Agenda
Hailey Planning and Zoning Commission
Monday, July 7, 2025
5:30 p.m.

STAFF REPORT
Hailey Planning and Zoning Commission
Regular Meeting of July 7, 2025

STAFF REPORT
Hailey Planning and Zoning Commission
Regular Meeting of July 7, 2025

ZONING AMENDMENT EXHIBIT

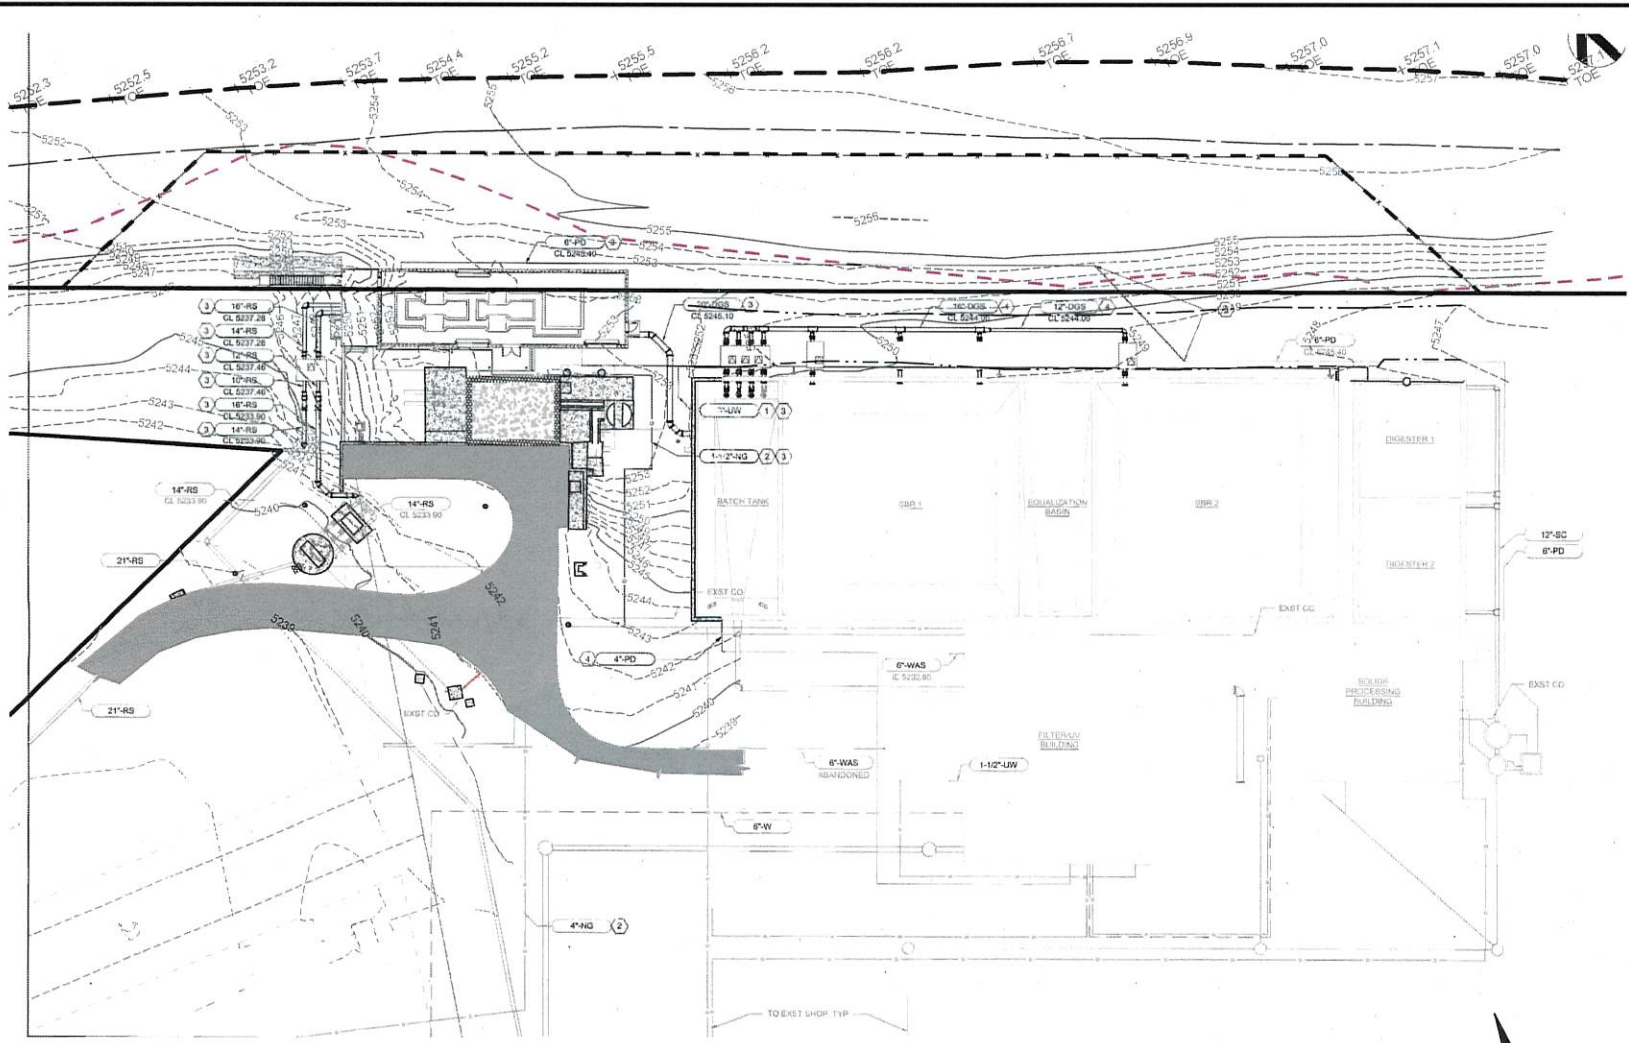
The subject property is located at the southernmost extent of Glenbrook Drive, in what is considered the South Woodside Light Industrial District. The Applicant is proposing to rezone the 20,600 square foot area of land from Recreational Green Belt to Light Industrial, to better accommodate for a new Wastewater Treatment Plant Headworks Facility. This parcel is buffered by other Light Industrial parcels (north and west) and is bound on the east by lands designated as Recreational Greenbelt (RGB). The land to the south of the parcel is currently being used for large-scale agriculture/open-space purposes and within unincorporated Blaine County, although the area is within Hailey’s Area of Impact (AOI). A concurrently submitted Lot Line Adjustment Application is intended to facilitate the Rezone Application and establish appropriate boundaries and buffers for the anticipated construction of a new Headworks Facility, approved by Hailey voters and funded via a revenue bond that was passed in 2023.

parcel: the “Toe of the Hill” Trail. While this segment of trail does not currently experience heavy use or traffic, other segments to the north do experience such use levels. As the City of Hailey contemplates possible annexation requests to the south of the subject property, and considers recommendations to connect Toe of the Hill Trail between Hailey and Bellevue, as outlined in the final [Blaine County Bike and Pedestrian Master Plan](#), the Applicant (namely, the Public Works Department of the City of Hailey) should consider and plan for such contexts in any final headworks facility design and site planning. This may entail additional fencing and/or landscape screening and avoiding any possible encroachments.

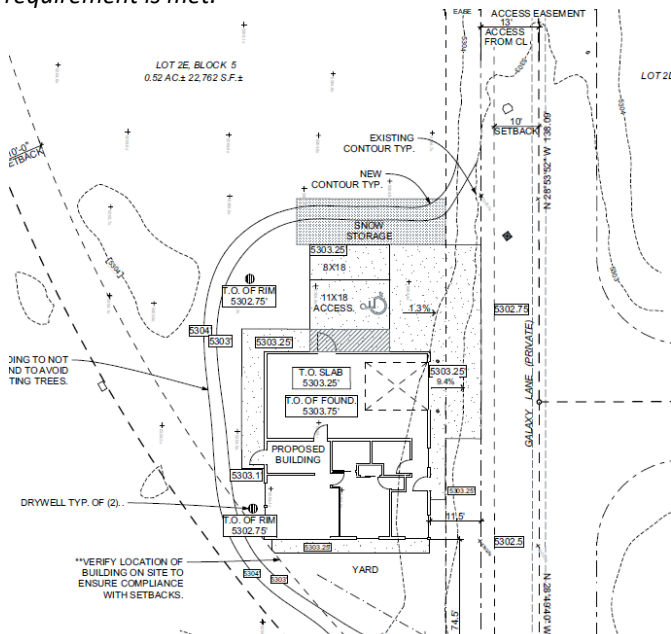
General Requirements for all Design Review Applications				
Compliant			Standards and Staff Comments	
Yes	No	N/A	City Code	City Standards and <i>Staff Comments</i>
<input checked="" type="checkbox"/>	<input type="checkbox"/>	<input type="checkbox"/>	17.06.050	Complete Application
<input checked="" type="checkbox"/>	<input type="checkbox"/>	<input type="checkbox"/>	Department Comments	Engineering: Life/Safety: Water and Sewer: Water: <i>The water meter vault is located in the asphalt on Comet Lane, next to the fire hydrant that the Applicant will need to connect to. The Applicant will</i>

<p><i>also need to leave all the water main line valves in the area exposed and accessible for inspection.</i></p> <p>Wastewater: The sewer stub for this lot is at the center of the lot on the north end, edge of right of way. This stub would need to be used.</p> <p>Building: <i>No comments</i></p> <p>Streets, Landscaping, Other:</p>
<input type="checkbox"/>	<input type="checkbox"/>	<input checked="" type="checkbox"/>	<p>17.08A Signs</p> <p>17.08A Signs: The applicant is hereby advised that a sign permit is required for any signage exceeding four square feet in sign area. Approval of signage areas or signage plan in Design Review does not constitute approval of a sign permit.</p> <p>Staff Comments</p> <p><i>N/A, no signage is proposed at this time. if the Applicant chooses to add signage at a later date, a Sign Permit Application shall be submitted and approved.</i></p>
<input checked="" type="checkbox"/>	<input type="checkbox"/>	<input type="checkbox"/>	<p>17.09.040 On-site Parking Req.</p> <p>See Section 17.09.040 for applicable code.</p> <p>Staff Comments</p> <p><i>The proposed project is located in the SCI-SO Industrial Zoning District. The Hailey Municipal Code requires a minimum of one (1) parking space per 1,000 square feet of commercial use. The project is approximately 1,554 square feet in size, with 943 square feet being commercial space. This requires the project to provide a total of one (1) onsite parking spaces to fulfill this standard. The Applicant has provided one (1) accessible onsite parking space for the commercial component of the development.</i></p> <p><i>The Accessory Dwelling Unit requires one (1) parking space per 1,000 square feet; the Applicant has provided one (1) parking space for the 611 square foot ADU. The Applicant has proposed a total of two (2) onsite spaces. The onsite parking requirement is met.</i></p>  <p>The diagram is a detailed site plan for Lot 2E, Block 5 (0.52 AC ± 22,762 S.F.). It shows a proposed building with a footprint of 8x18 and 11x18. Key features include: <ul style="list-style-type: none"> EXISTING CONTOUR TYP. and NEW CONTOUR TYP. lines. SNOW STORAGE area. PROPOSED BUILDING with various rooms. YARD area. UTILITIES: T.O. OF RIM (5302.75, 5302.72), T.O. SLAB (5303.25), F.O. OF FOUND (5303.75). SETBACKS: 10' FRONT, 5' SIDE, 10' REAR. ACCESS EASEMENT FROM CL. and GALAXY LANE (PRIVATE). Other labels: DRYWELL TYP. OF (2), YARD, YARD, YARD. </p>

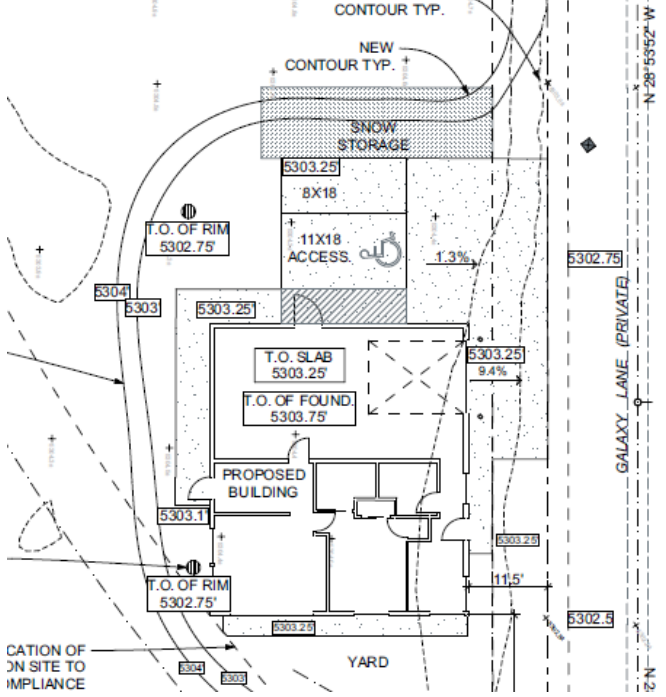
Compliant			Standards and Staff Comments	
Yes	No	N/A	City Code	City Standards and Staff Comments
<input checked="" type="checkbox"/>	<input type="checkbox"/>	<input type="checkbox"/>	17.06.080(A)1a	<p>a. The location, orientation and surface of buildings shall maximize, to the greatest extent possible sun exposure in exterior spaces to create spaces around buildings that are usable by the residents and allow for safe access to buildings.</p> <p><i>Staff Comments</i></p> <p>While most of the adjoining parcels are vacant, the proposed building's primary walls are oriented east/west, which is consistent with other industrial properties to the west, and throughout the subdivision. An open space area is proposed to be located toward the southern portion of the building, providing a usable space for the residents of the ADU as required by code.</p>
<input type="checkbox"/>	<input type="checkbox"/>	<input checked="" type="checkbox"/>	17.06.080(A)1b	<p>b. All existing plant material shall be inventoried and delineated, to scale, and noted whether it is to be preserved, relocated or removed. Removal of trees larger than 6-inch caliper proposed to be removed require an arborist review. Any tree destroyed or mortally injured after previously being identified to be</p>

<p>preserved, or removed without authorization, shall be replaced with a species of tree found in the Tree Guide and shall be a minimum of 4-inch caliper.</p> <p><i>Staff Comments</i> The site contains some existing mature trees along the northwestern side of the parcel that will remain in place.</p>
<input checked="" type="checkbox"/>	<input type="checkbox"/>	<input type="checkbox"/>	17.06.080(A)1c	<p>c. Site circulation shall be designed so pedestrians have safe access to and through the site and to building.</p> <p><i>Staff Comments</i> Access to the site is proposed off Galaxy Lane. Safe pedestrian access is provided through a new paved driveway and a walkway which leads to the front of the commercial building as well as the rear of the building where the entrance to the ADU is located.</p> 
<input checked="" type="checkbox"/>	<input type="checkbox"/>	<input type="checkbox"/>	17.06.080(A)1d	<p>d. Building services including loading areas, trash storage/pickup areas and utility boxes shall be located at the rear of a building; the side of the building adjacent to an internal lot line may be considered as an alternate location. These areas shall be designed in a manner to minimize conflict among uses and shall not interfere with other uses, such as snow storage. These areas shall be screened with landscaping, enclosures, fencing or by the principal building.</p> <p><i>Staff Comments</i> The Applicant is proposing rollout trash bins that will be kept inside and brought out during waste collection. No dumpster is proposed for the site, or use.</p> <p>The proposed meter is located at the back of the building and will be screened by a fence. This has been made Condition of Approval.</p>
